SUBJECT: CERTIFICATION OF THE MINUTES OF THE ACRS SUBCOMMITTEE ON THE AP1000 REACTOR, NOVEMBER 2-3, 2010, ROCKVILLE, MARYLAND

REVISION 17 TO AP1000 DESIGN CONTROL DOCUMENT APPLICATION

November 2-3, 2010
ROCKVILLE, MARYLAND

IRWST Injection Path - No Void Present

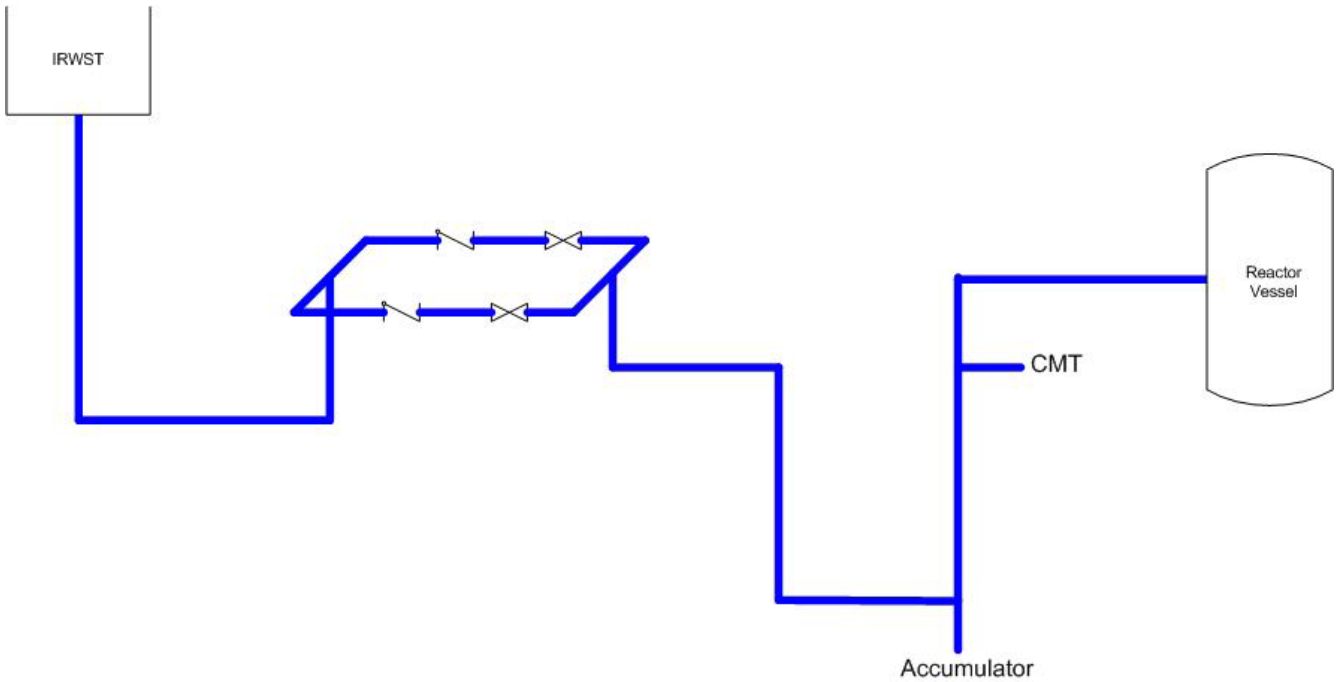
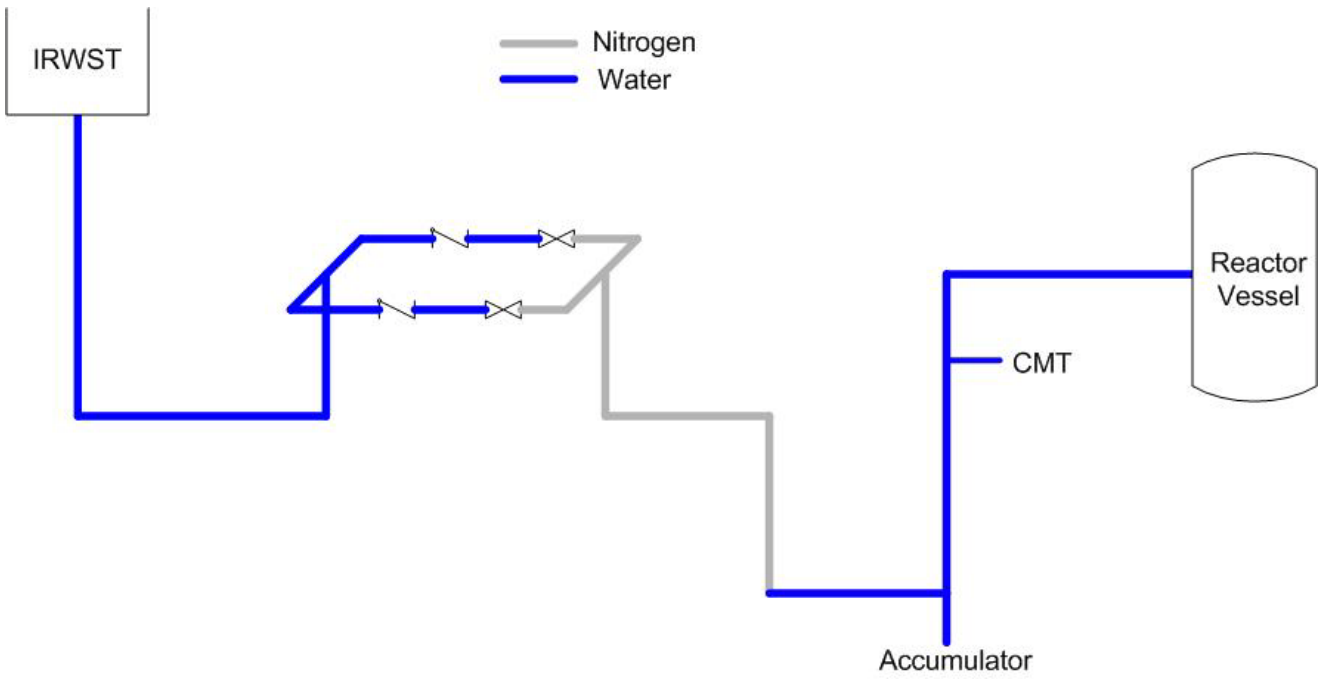
- One Open Item (2b) from the February 2010 ACRS meeting was to supplement the sensitivity analysis (core mixture level) provided with a core heatup calculation

[NOTE: (IRWST Valve Elevation – IRWST Injection Tee Elevation) * Density of IRWST Fluid ≈3.4 psi]

- CN66 changes evaluated as part of SER Chapter 23
- CN66 SER inputs are complete – No further action
- Added DCD Subsection 6.3.6.3 (discusses Mitigation of Gas Accumulation)
  - Includes a discussion of the ISG-019 / GL 2008-01 gas intrusion assessment
  - Summarizes the gas mitigation design features
- DCD Subsection 6.3.6.3.2 (System Design Features to Mitigate Gas Intrusion) includes specific line sloping design / construction / fabrication requirements
- A new ITAAC is not required
